PROPOSED TYPICAL SECTION
VETERANS MEMORIAL DRIVE TRAIL
STA. 76+40.34 TO STA. 102+02.78

FILE NAME 10/11/14	USER NAME KJS	DESIGNED -	REVISED KJS 9/4/14	HMG ENGINEERS, INC. ENGINEERS - SURVEYORS CARLYLE, ILLINOIS 62231 (618) 594-3711	CITY OF MOUNT VERNON 1100 MAIN STREET, P. O. BOX 1708 MT. VERNON, ILLINOIS 62864 (618) 242-5000	TYPICAL SECTIONS		F.A.U. RTE.	PROJECT VETERANS & 34TH TRAIL	COUNTY JEFFERSON	TOTAL SHEETS 41	SHEET NO. 4
PLOT SCALE 1"=40'	DATE 10/11/14	DRAWN -	REVISED -			SCALE:	SHEET OF SHEETS	STA.	TO STA.	SECTION 10-00133-00-BT	CONTRACT NO. 99534	HMC JOB NO. 7004

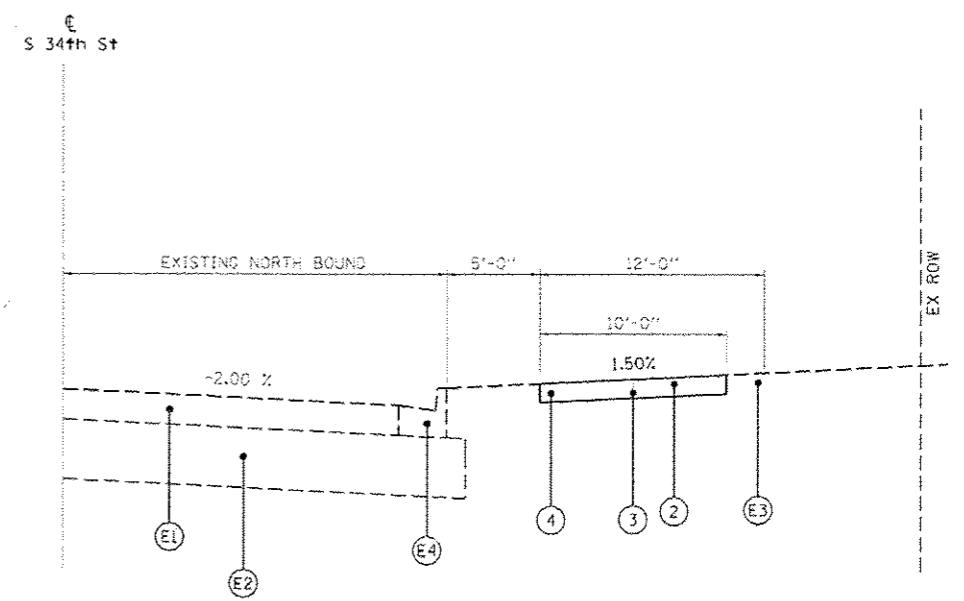
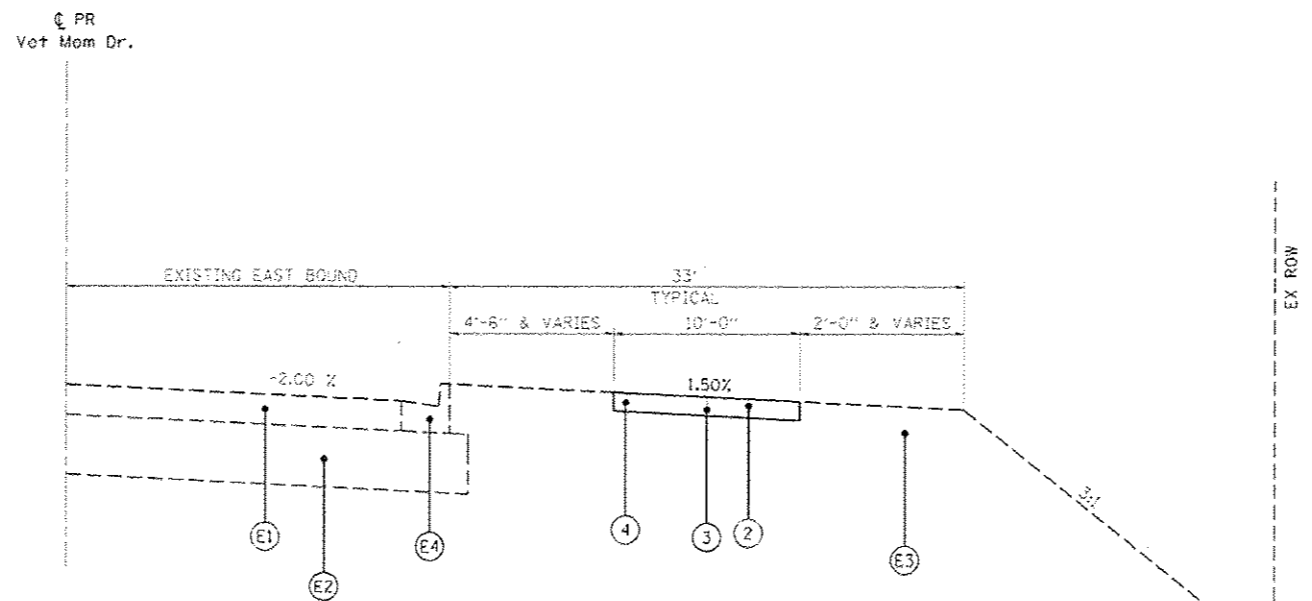
REVISION 9/4/14 - PROFILE REVISION STATION 80+37.17 TO 87+51.38
- REMOVED LIME MODIFICATION OF EXISTING SOIL
